**Rezoning Application:** PRS 25-0795

**BOCC Land Use Meeting Date:** July 22, 2025

**Development Services Department**

PD 22-1705 was approved in 2023 to allow for the development of a three-story mini warehouse facility and accessory open storage on Parcel A and limited CI uses on Parcel B. The applicant is requesting a modification to Pod A of the PD to replace the mini warehouse use with a warehouse with wholesale distribution.

2.4 Proposed Site Plan (partial provided below for size and orientation purposes. See Section 8.0 for full site plan)

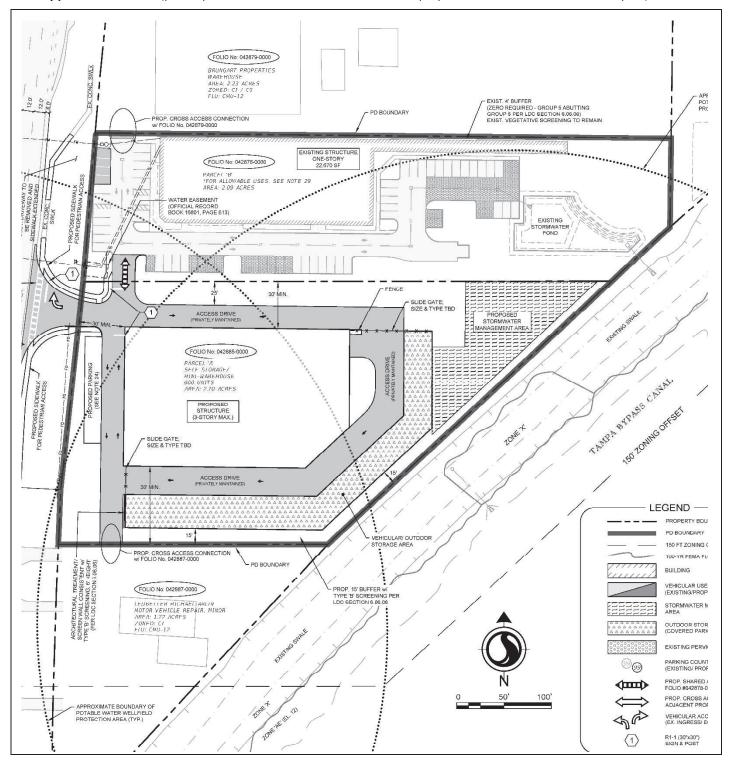
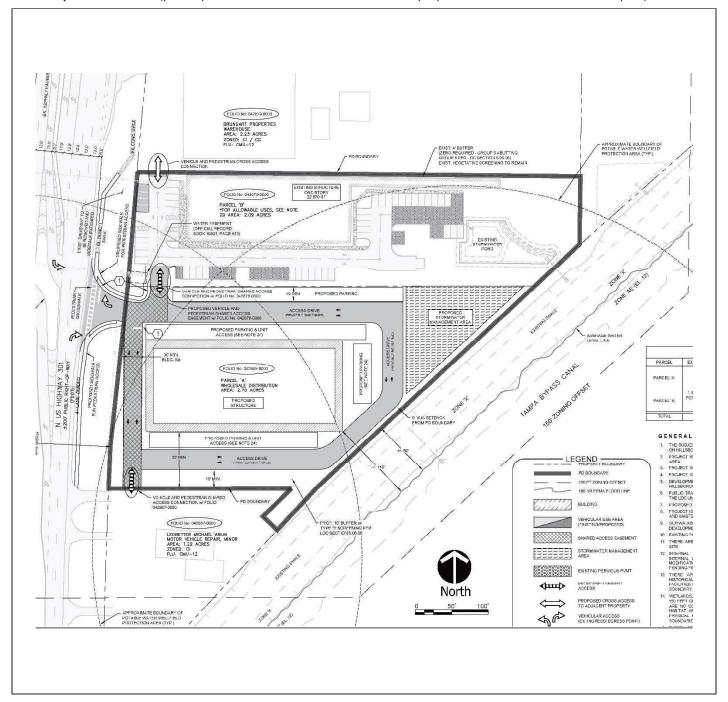
Existing Approvals	Proposed Modifications
Parcel A: 81,420 SF of mini warehouse with up to 600	Parcel A: (1) 35,283 SF of Wholesale Distribution &
storage units and 24,426 SF of accessory open storage.	Warehouse and (2) alter the building envelop
Parcel A: 15-foot Type B buffer along southern and	Parcel A: Reduce the 15-foot Type B buffer along the
southeastern property boundaries. (Not required per	southeastern property boundary to 6 feet to
LDC, Section 6.06.06)	accommodate a vehicular use area buffer.

Prior to PD Site Plan Certification, the developer shall revise the PD site plan to:

- 2. Development within Parcel A shall be restricted to a maximum of 81,420-35,283 s.f. of wholesale distribution and warehouse use.mini-warehouse uses with a maximum of 600 storage units, and up to 24,426 s.f. of accessory outdoor open storage uses.

PLAN SHEET ALTERNATIVE 2

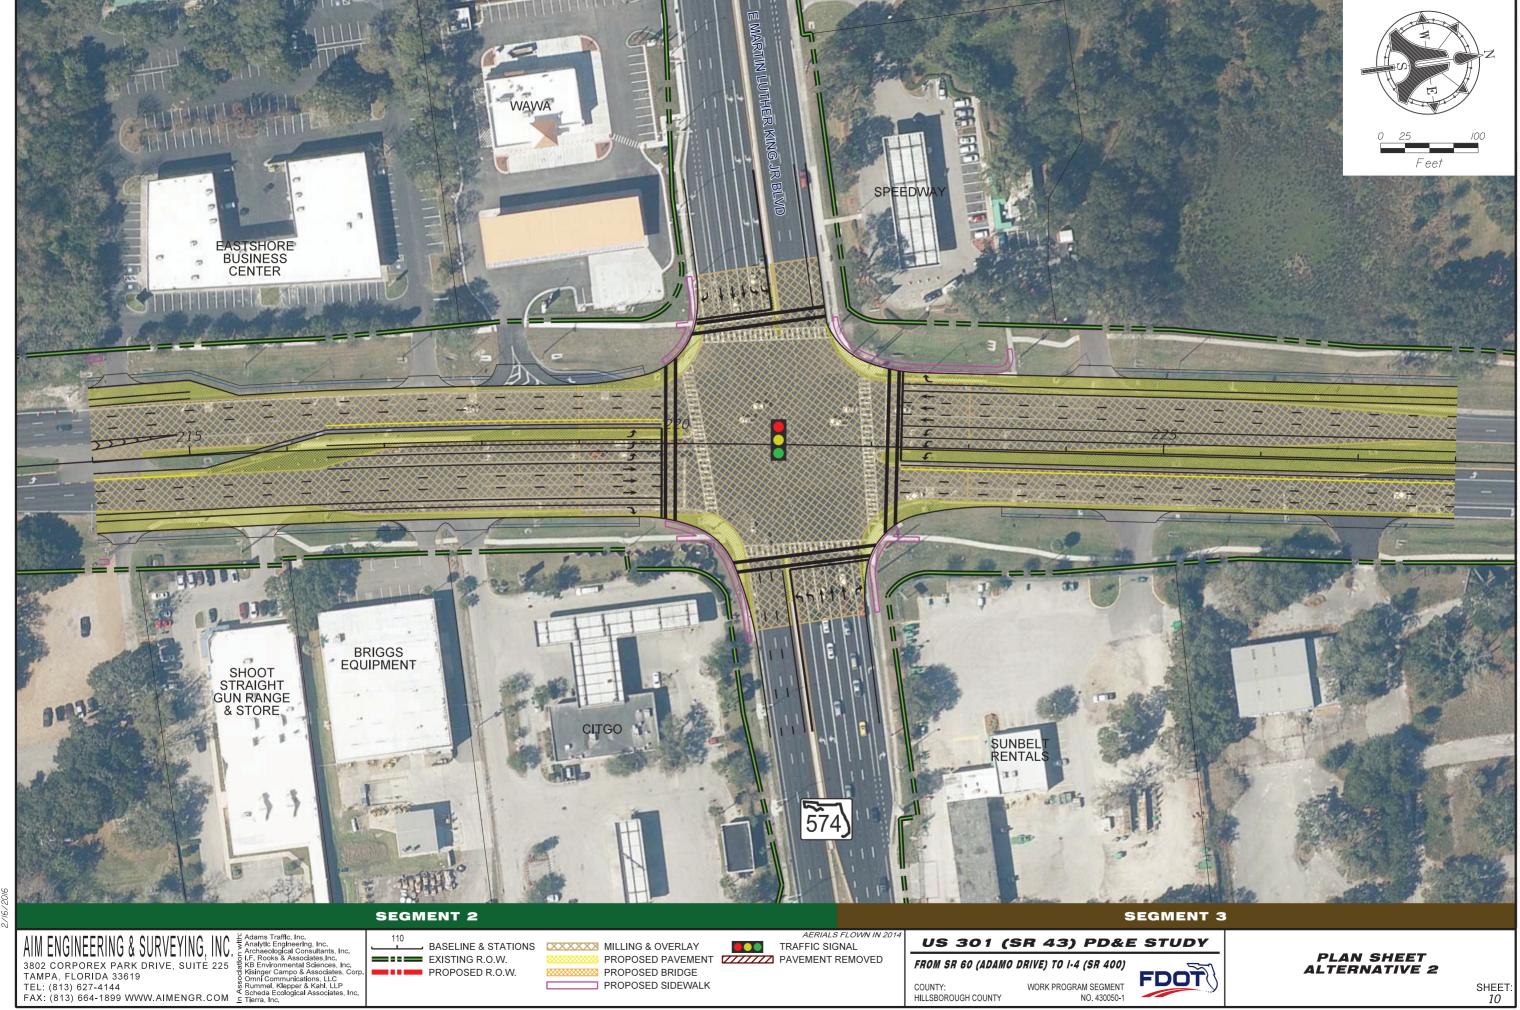
Please be advised that FDOT conducted a Project Development & Environment (PD&E) study to consider widening a portion of SR 43 (US 301) that extends from SR 60 to south of I-4. It does not appear that ROW is needed from this parcel, but the medians are to be modified (closed and directionalized). The concept pages from the PD&E are attached.

JULY 2021 SCALE: 1"=30' SITE PLAN

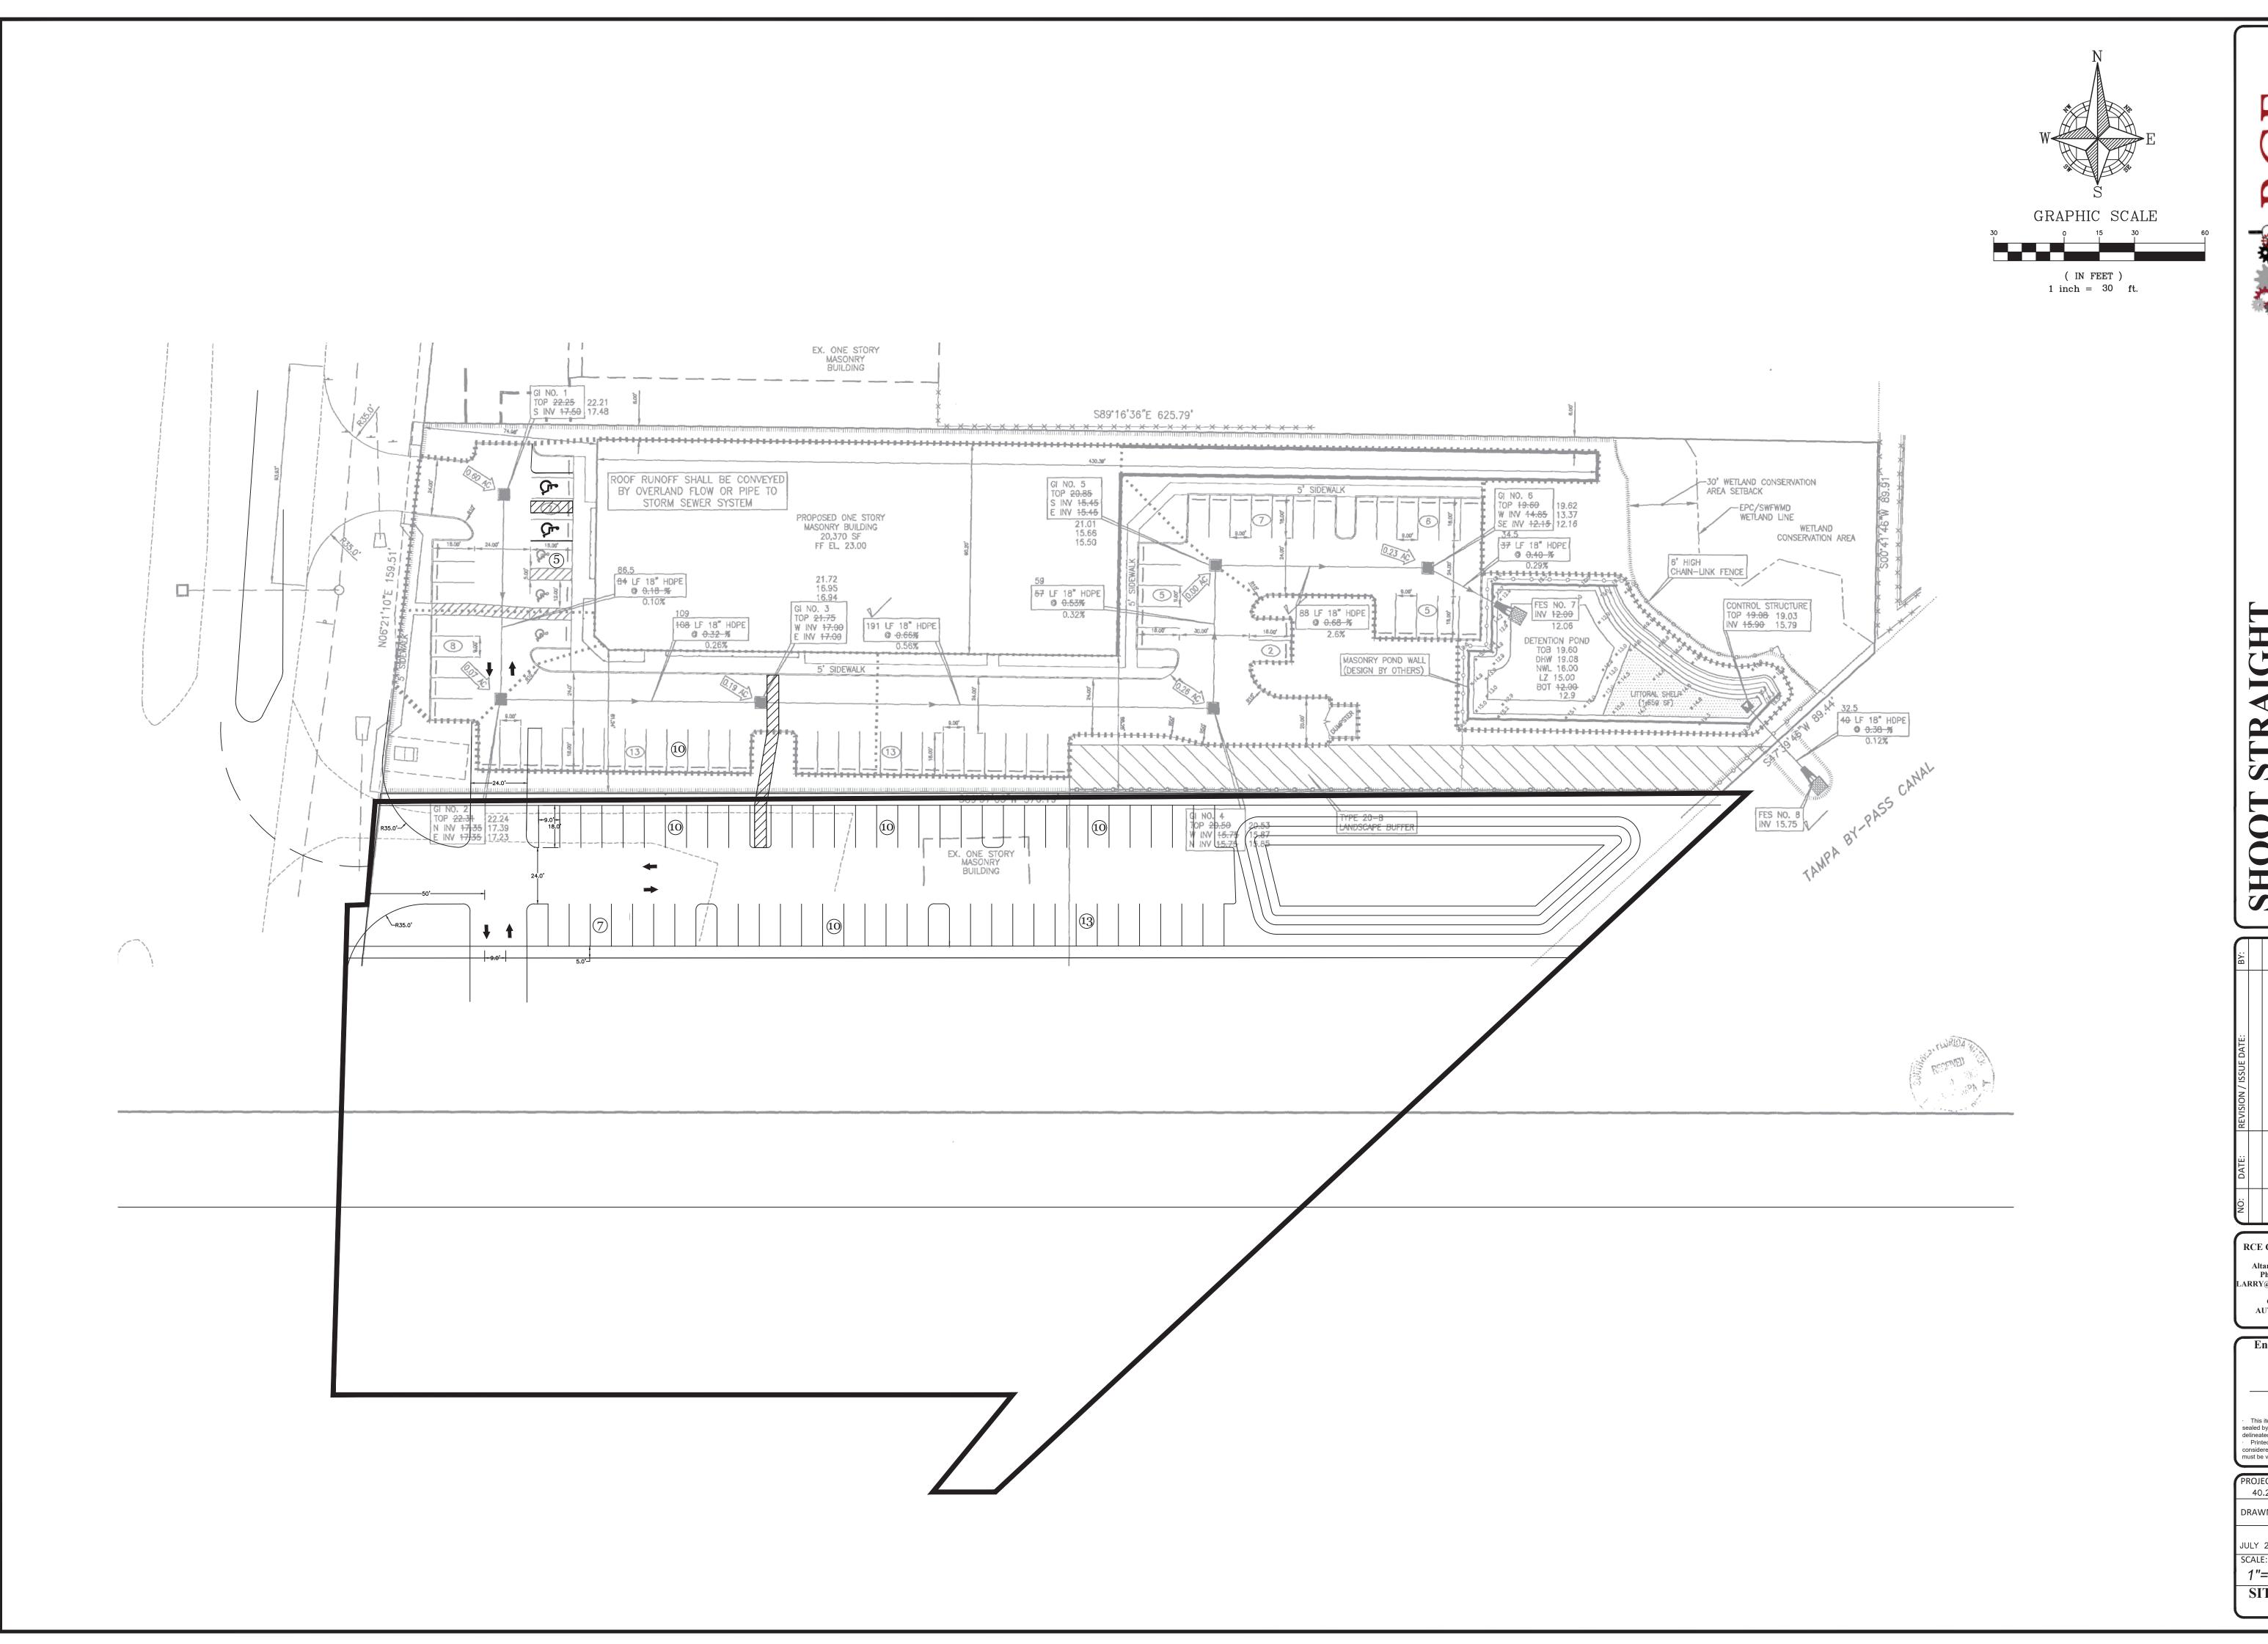
- 1. Proposing an ±85Kft² storage building with RV and vehicle storage and a loading area from a vacant lot.
- FDOT PD&E for future expansion of US 301 shows the median opening in front
  of the property being closed. Project is currently in design and is not in the 5-year
  plan and is unfunded. FDOT project # 430050-1, project manger is Craig Fox
  craig.fox@dot.state.fl.us

- 4. The new driveway design will need to have 50' radii with 5' paved shoulders that wrap around and tie into the ROW. Label all geometry dimensions on the plans.

- 5. Provide cross access stub-out to the north.
- 6. No stub-out to the south will be required.
- 7. A sidewalk connection to the state road will be required.

- 10. The site seems to drain to the canal in the current condition.
- 11. Provide existing and proposed drainage maps.
- 12. If the property drains to the state system or there is an existing structure or system, either active or inactive, in the existing or proposed condition, then a drainage permit will be required. If it does not discharge to any state system, then it may qualify as a drainage exemption. Complete the attached exception questionnaire to determine which you will need to apply for.
